# Mask Set Errata for Mask 0L78P

This mask set errata applies to the mask 0L78P for these products:

- MC9S08RE16
- MC9S08RE8
- MC9S08RD16
- MC9S08RD8
- MC9S08RC16
- MC9S08RC8

## HCS08 with External Oscillator — Falling Edge on $\overline{\text{RESET}}$ During Termination of Reset Events

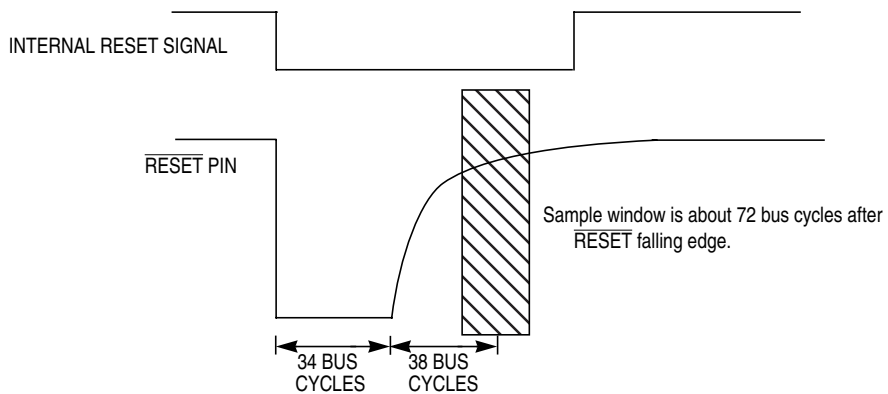
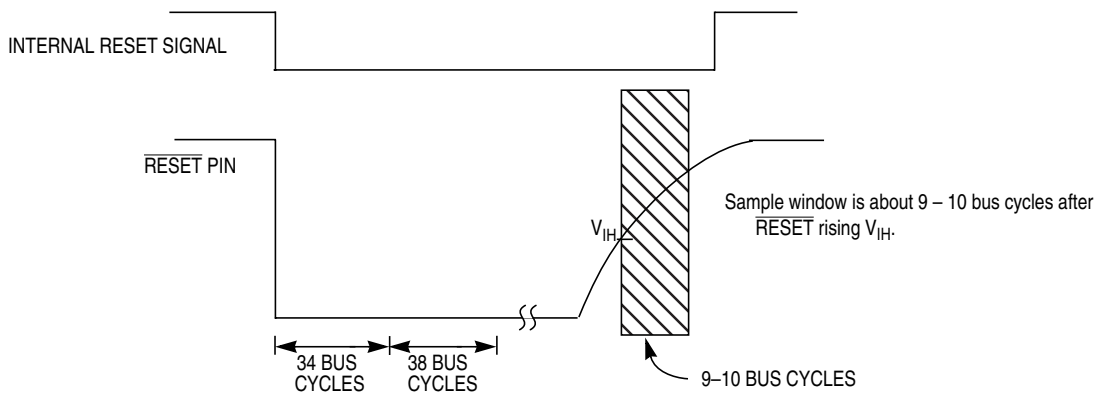
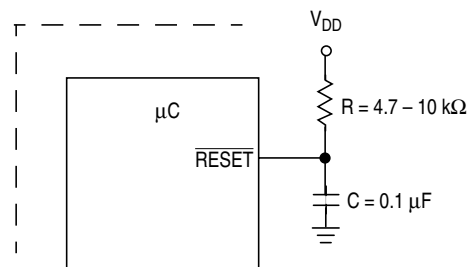
If a falling edge is detected on the external reset pin at either of two sample points, the MCU will cease operation and will recover only after a power-on reset.

**Case 1** — After detecting a reset signal, either internal or external, the internal reset circuit latches the cause of the reset, forces a low level on the external  $\overline{\text{RESET}}$  pin for about 34 bus cycles, releases the pin, and samples the pin level about 38 bus cycles later.

**Case 2** — After remaining in reset for an extended period of time due to an externally applied low level on  $\overline{\text{RESET}}$ , the internal reset circuit will sample the pin level about 9 to 10 bus cycles after the pin raises above its  $V_{IH}$  level.

To avoid multiple edges on the  $\overline{\text{RESET}}$  pin due to switch contact ringing or EMC noise, eliminate any voltage bounce through RC filtering. A 0.1  $\mu\text{F}$  capacitor to ground and an external 4.7 k $\Omega$  to 10 k $\Omega$  resistor to  $V_{DD}$  works well to ensure noise suppression.

In addition to RC filtering, avoid spurious edges on the  $\overline{\text{RESET}}$  pin caused by external active circuitry such as low voltage detectors and watchdog components. Do this by ensuring that external circuitry cannot drive  $\overline{\text{RESET}}$  low within 10 bus cycles of the release of  $\overline{\text{RESET}}$ .
